## SB MT102-02 Service Bulletin for MT102 Magnetic Transducer Accessory

Date: March 28, 2014  
Regarding: MT102 Cable  
SB Revision: A

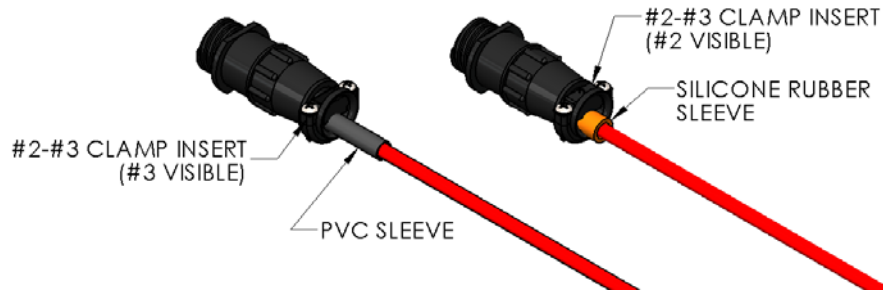
This Service Information Letter is applicable to MT102 units that do not have a sleeve on the cable installed by Sandel as shown in the following image.

Without the presence of a cable sleeve on the MT102 cable, there may be excessive clamping force on the cable resulting in shorting of the individual wires in the cable bundle. To alleviate this potential issue, the cable clamp force may be reduced by loosening the two screws on the clamp.

Back the screws out until they are loose and then retighten them until the clamp contacts the cable while not exerting excessive force. The screws should just be snug. The distance between the connector housing and the cable clamp should be approximately 0.125" as shown in the following image.
